MLC BURWOOD SENIOR SCHOOL CENTRE (SSD 6484) RESPONSE TO SUBMISSIONS

This letter and its attachments set out the proponent's response to the additional information requested by the Department of Planning and Environment (the Department) in your letter dated 20 November 2014.

Existing separation between 31A & 31 Park Rd

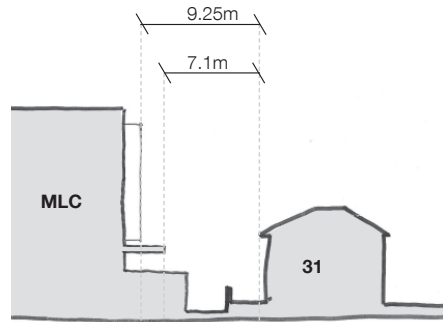
Provide a detailed section plan through the interface with the adjoining property at No. 31 Park Road (including the dwelling house) showing the proposed landscape treatment, boundary fencing (including wall height and construction type) and dimensions to the building elements on the subject site

This detail is provided at page 22 of BVN's Design Report (provided at Appendix D of the EIS submission). This plan is re-attached for convenience. As detailed on the plan, the following treatments have been incorporated into the design at the interface with 31 Park Road:
